Proposal to replace document ECE/TRANS/WP.29/GRBP/2024/07

I. Proposal

Figure 1
Nomenclature explanation related to grip index of the tyre

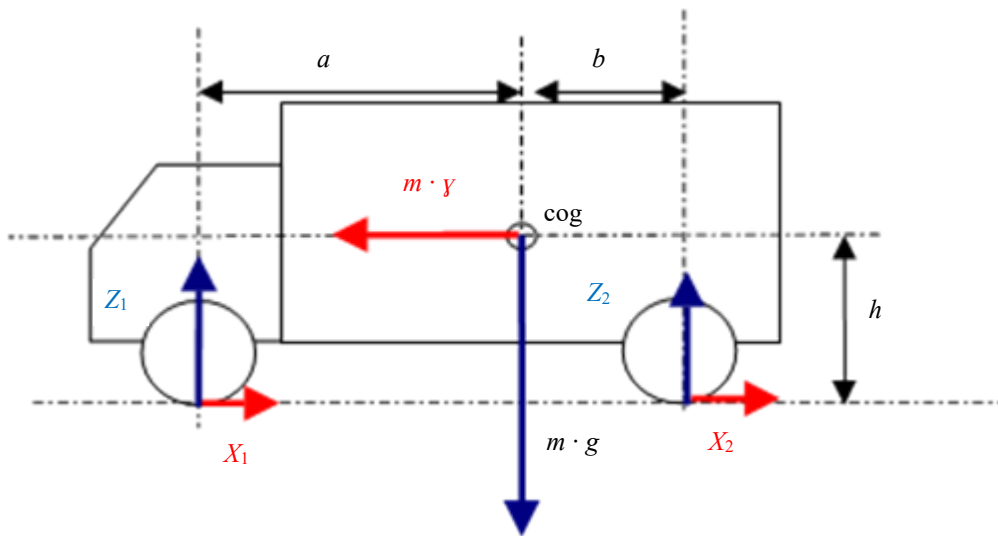
"2.2.2.7.5. Calculation of the relative wet grip index of the tyre

The wet grip index represents the relative performance of the candidate tyre compared to the reference tyre. The way to obtain it depends on the test configuration as defined in paragraph 2.2.2.2. of this Annex. The wet grip index G of the tyre is calculated as reported into Table 7:

Configuration C1: candidate tyres on both axles	$G = f \cdot \frac{BFC(T)}{BFC(R)}$
Configuration C2: candidate tyres on front axle and reference tyres on rear axle	$G = f \cdot \frac{BFC(T) \cdot [a + b + h \cdot BFC(R)] - a \cdot BFC(R)}{BFC(R) \cdot [b + h \cdot BFC(T)]}$
Configuration C3: reference tyres on front axle and candidate tyres on rear axle	$G = f \cdot \frac{BFC(T) \cdot [-a - b + h \cdot BFC(R)] + b \cdot BFC(R)}{BFC(R) \cdot [-a + h \cdot BFC(T)]}$

<i>For class C2 tyres</i>	
<i>SRTT16C</i>	
<i>f = 1</i>	
<i>For class C3 tyres</i>	
<i>SRTT19.5, SRTT22.5</i>	<i>SRTT19.5 siped, SRTT22.5 siped</i>
<i>f = 1</i>	<i>f = 1.04 1.02</i>

- f:** correction factor depending on used SRTT
- cog:* centre of gravity of the loaded vehicle
- m:* mass (in kilograms) of the loaded vehicle
- a:* horizontal distance between front axle and centre of gravity of the loaded vehicle (m)
- b:* horizontal distance between rear axle and centre of gravity of the loaded vehicle
- h:* vertical distance between ground level and centre of gravity of the loaded vehicle (m).
